CENWS-OD-TS-DMMO

MEMORANDUM FOR: RECORD January 8, 2015

SUBJECT: DETERMINATION REGARDING THE SUITABILITY OF PROPOSED DREDGED MATERIAL FROM PHASE 1 OF THE PORT OF TACOMA PIER 4 CLEANUP AND RECONFIGURATION PROJECT EVALUATED FOR UNCONFINED OPEN-WATER DISPOSAL AT THE COMMENCEMENT BAY DISPOSAL SITE OR BENEFICIAL USE

Figure 2 PHASE 1 DREDGE PLAN

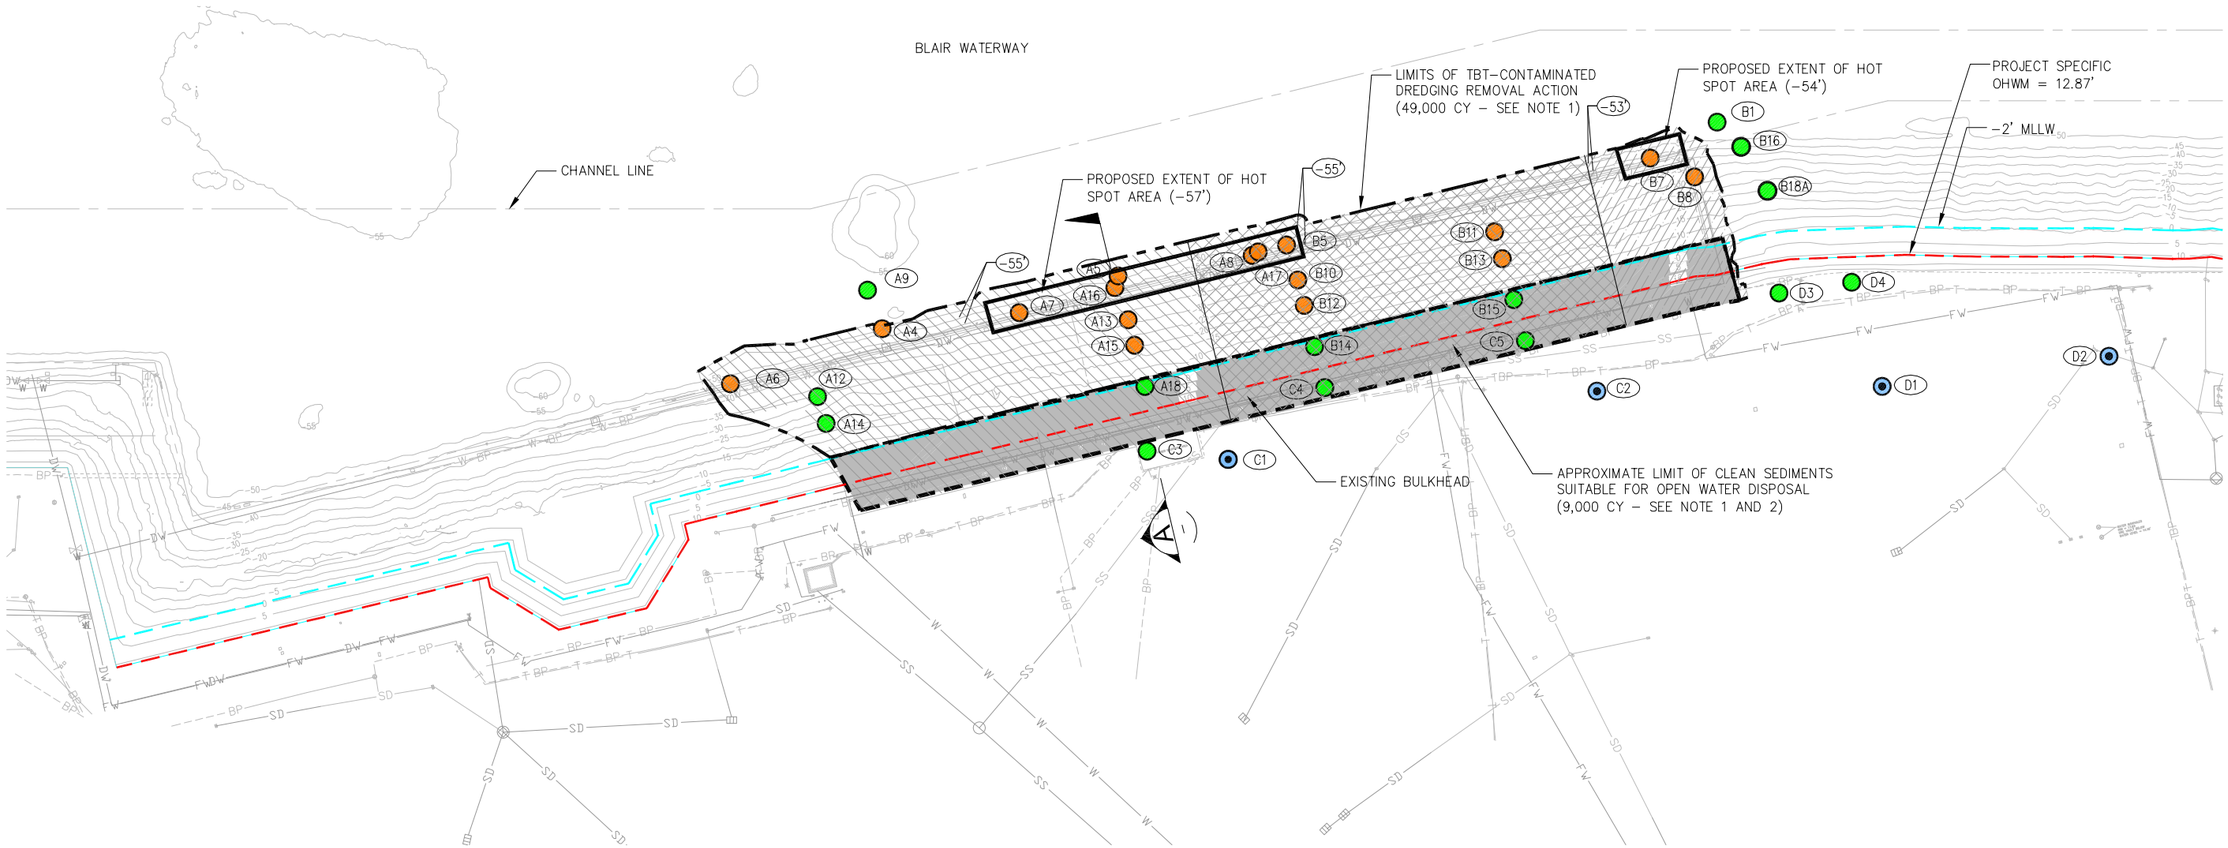
Phase 1
   Removal of approximately 49,000 cy of TBT-contaminated sediment will be removed under an AOC between the Port of Tacoma and USEPA (Floyd|Snider, 2014). Prior to removal of the contaminated material along the slope and at the pier face, the upper portion of the slope must be removed to maintain slope stability. This suitability determination applies only to the 11,300 cy of top-of-slope dredged material, see Figure 2.

The sample locations considered in this suitability determination are shown in Figures 2 & 3 and are summarized below:

Figure 4.1
Pier 4 Sediment and Soil Sample TBT Results

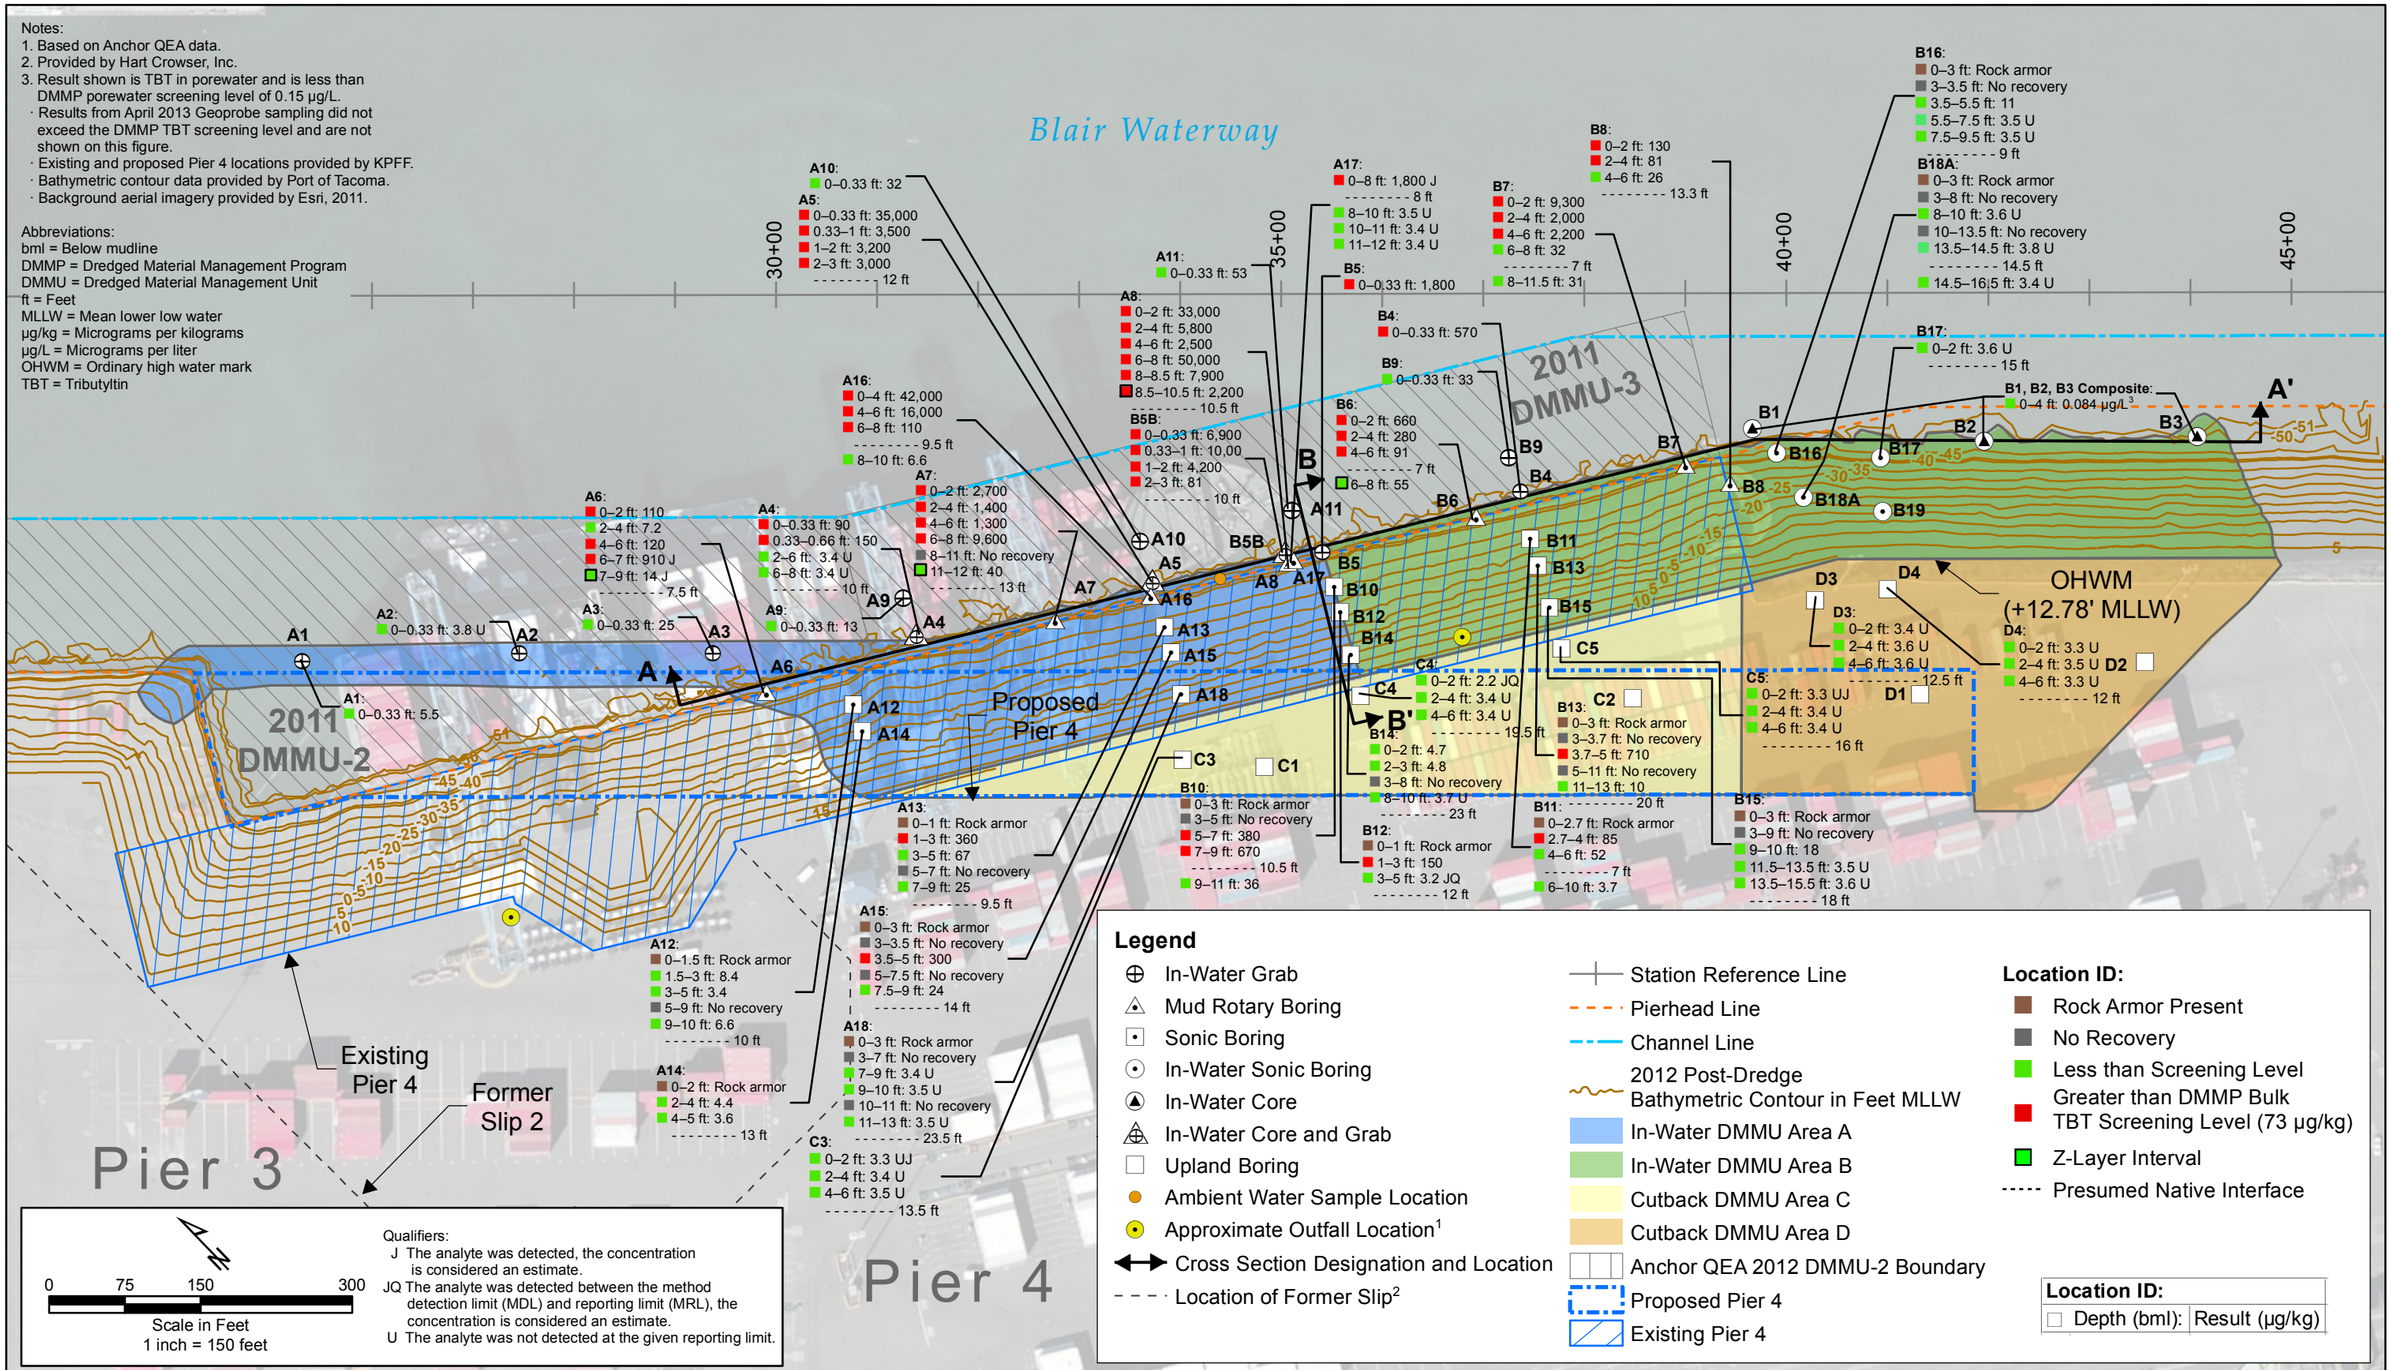
5. Sampling. As mentioned above, sampling over the entire project area took place over four events between April 2013 and July 2014. A detailed description of the activities and results from each sampling event can be found in the Pier 4 Phase 2 Reconfiguration Project Sediment Characterization Report (Floyd|Snider, 2014a). Figure 4.1 includes all the results from all sampling events.

FIGURE 3 - PHASE 1 DREDGE PLAN

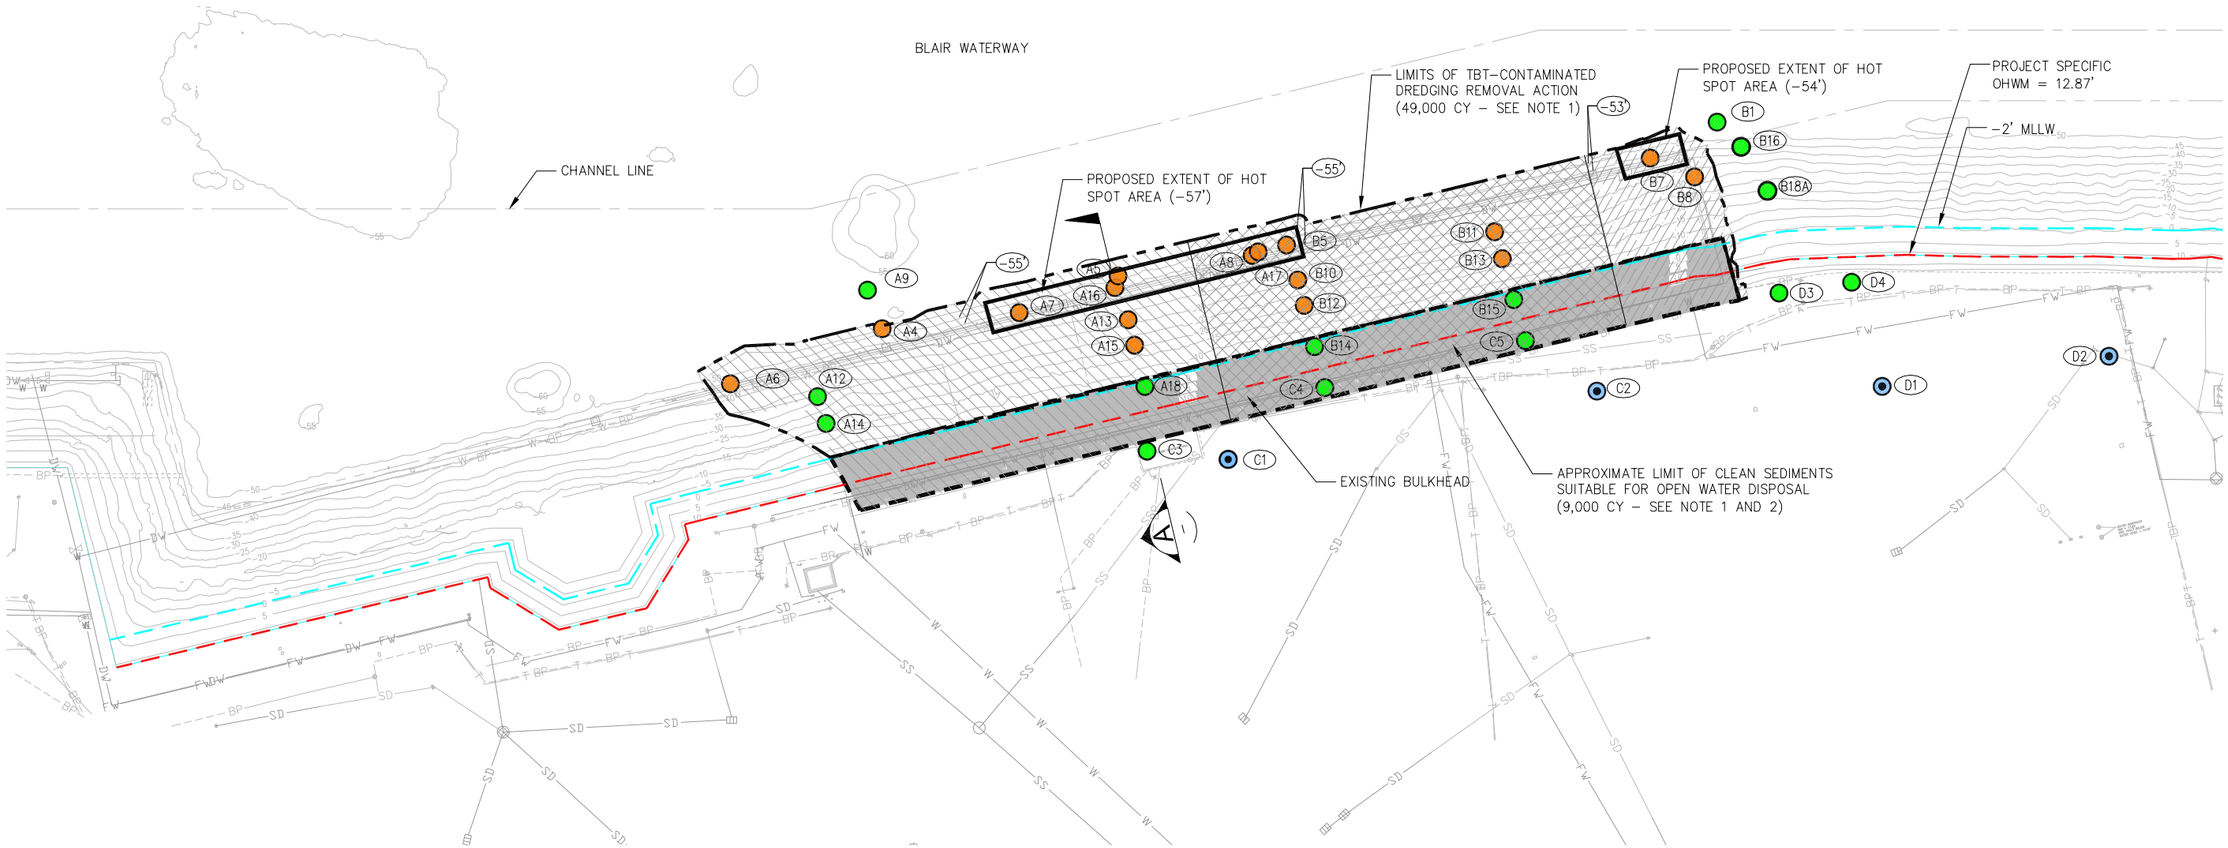
Soil sampling conducted in April 2013 found no exceedances of any of the DMMP screening levels (SLs) in any upland location, as shown by the blue symbols in Figures 3 and 4.

In July 2014, five upland borings (C3, C4, C5, D3, and D4) were advanced in order to define the boundary between the upland DMMUs and the in-water DMMUs. Sample Locations C3, C4, and C5 were positioned in-line with and shoreward of under-pier Sample Locations A18, B14, and B15 (described below). Based on previous sampling events, native material has been confirmed to be clean. Native material was encountered at depths ranging from 13.5 to 19 feet below ground surface (bgs). The top three samples collected from C3, C4, and C5 were analyzed for bulk TBT. TBT was detected at 2.2 micrograms per kilogram (µg/kg) in the surface sample collected from C4, and remaining sample results for all locations were non-detect at laboratory reporting limits ranging from 3.3 to 3.5 µg/kg. These sample locations are shown as green symbols on Figure 3.

northern end of the pier, detected TBT concentrations were less than the DMMP SL (Figure 3). Sample recovery was generally good immediately below the riprap rock armor in this area. At Sample Location A12, TBT was detected at 8.4 µg/kg in the shallowest sample, 1.5 to 3 feet below mudline (bml), able to be collected from below the riprap rock armor and at 3.4 µg/kg in the underlying 3 to 5 feet bml sample. At Sample Location A14, TBT was detected at 4.4 µg/kg in the shallowest, 2 to 4 feet bml sample able to be collected and 3.6 µg/kg in the underlying 4 to 6 feet bml sample. Native material was encountered at -40 feet MLLW at A12 and -30 feet MLLW at A14. These sample locations are shown as green symbols on Figure 3.

Native material at Sample Locations A18, B14, and B15 was encountered at elevations between -20 feet and -26 feet MLLW. The top four samples that were able to be collected from Sample Locations A18, B14, and B15 were analyzed for bulk TBT. TBT was detected in the top (0 to 2 feet bml) and the 2 to 3 feet bml samples collected from B14 (4.7 µg/kg and 4.8 µg/kg, respectively). At B15, TBT was detected at 18 µg/kg in the uppermost (9 to 10 feet bml) sample able to be collected. All TBT detections were significantly less than the DMMP TBT SL of 73 µg/kg. TBT was not detected in the samples collected from A18, or deeper samples collected from B14 and B15, at laboratory reporting limits ranging from 3.4 to 3.7 µg/kg. These sample locations are shown as green symbols on Figure 3.

Figure 3 shows the dredge plan of the top of slope 9,000 CY of clean, non-TBT-contaminated sediments, and the downslope TBT-contaminated sediments. Also shown on Figure 3 are the material characterization sample locations, as described above. Removal of the clean top of slope material will be conducted either from the uplands with the use of a crawler crane or from a mechanical bucket dredge on a floating derrick barge. The thickness of the dredge cut along the slope through the entire Phase 1 dredge prism varies based on the depth of detected TBT concentrations greater than the DMMP SL. The slope dredge cut thicknesses of 9 feet, 11 feet, and 8 feet, as indicated on Figures 3 and 4, apply to both the top of slope clean material and the downslope TBT-contaminated material.

FIGURE 4 - DREDGE SECTION A

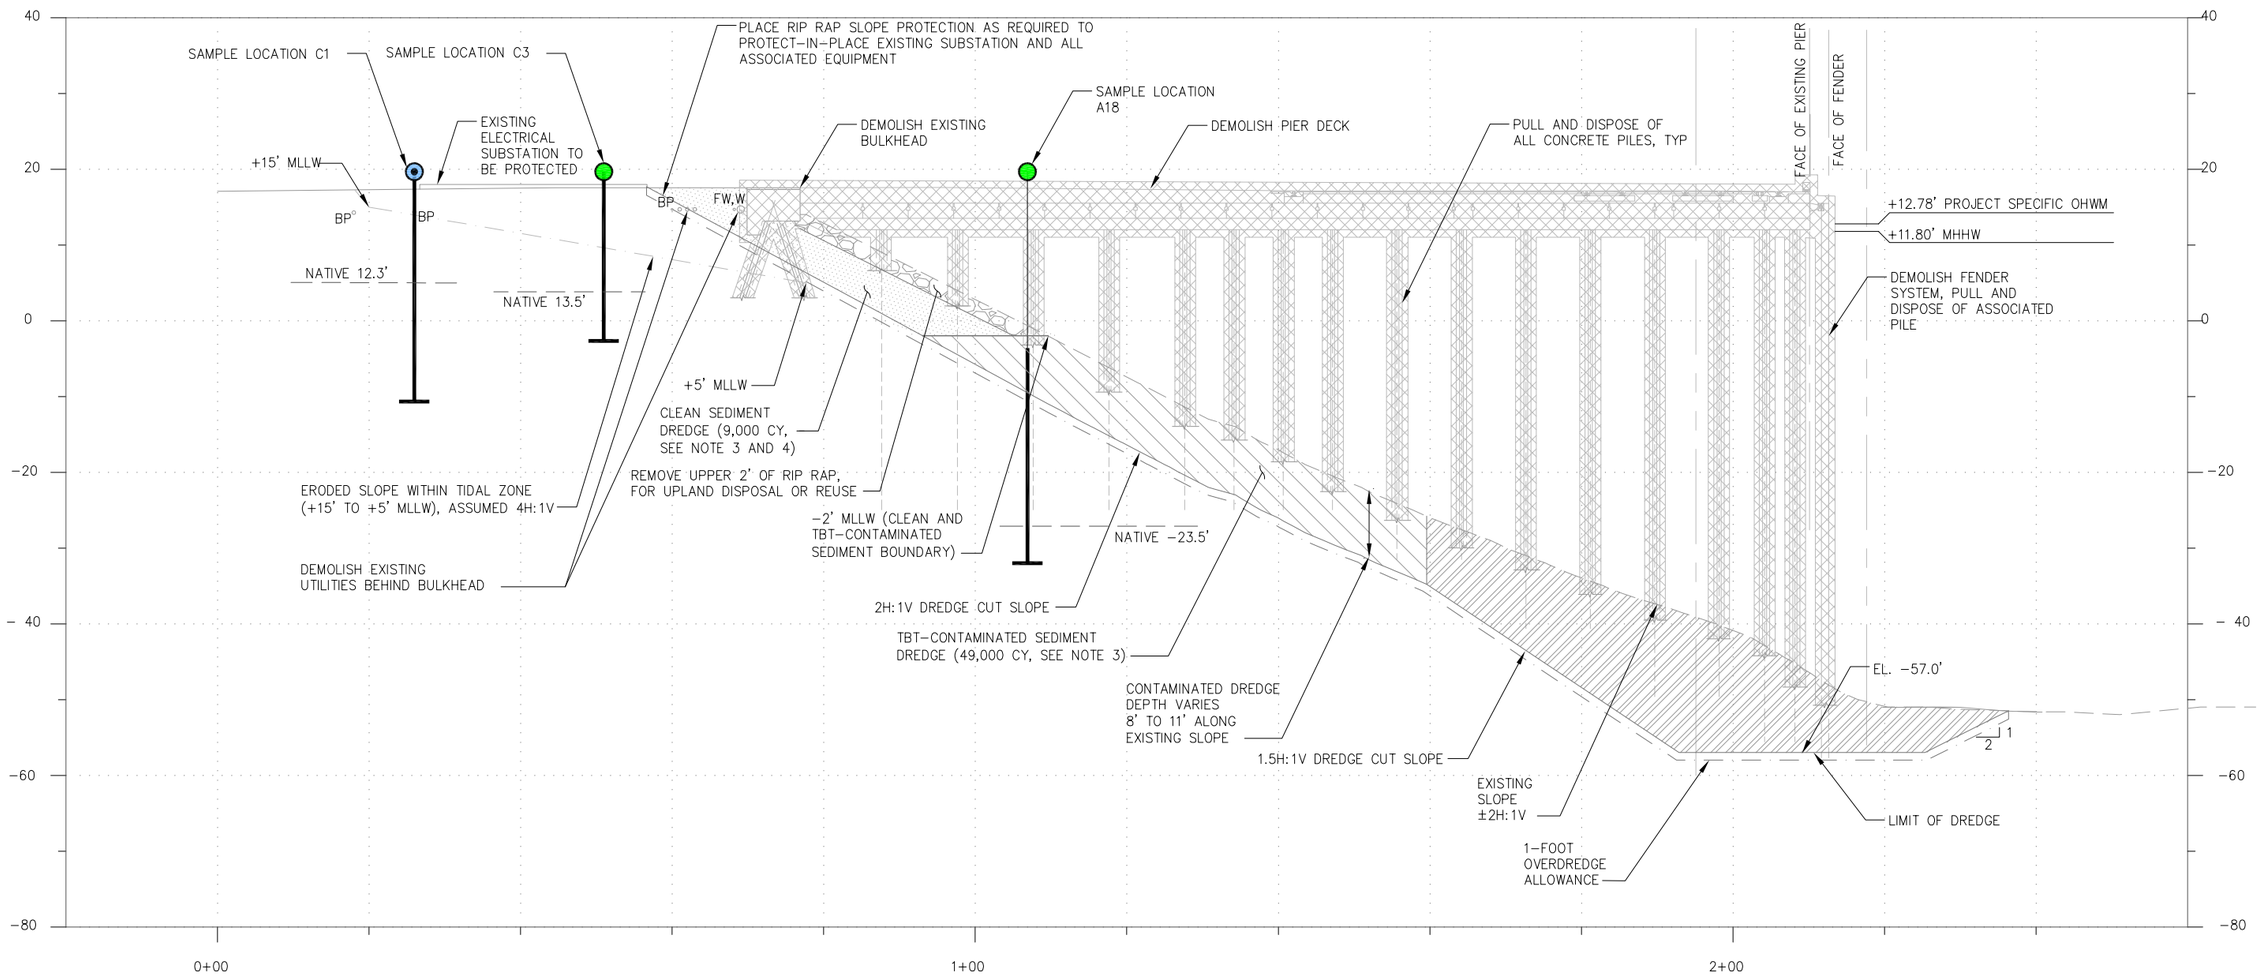
Figure 4 also shows the location of the pier face fender system, which includes creosote-treated timber and steel piles, as well as the under-pier 16.5-inch-diameter concrete piles. The piles

located within the clean, top of slope material and the downslope TBT-contaminated material, are concrete piles until the pier face.
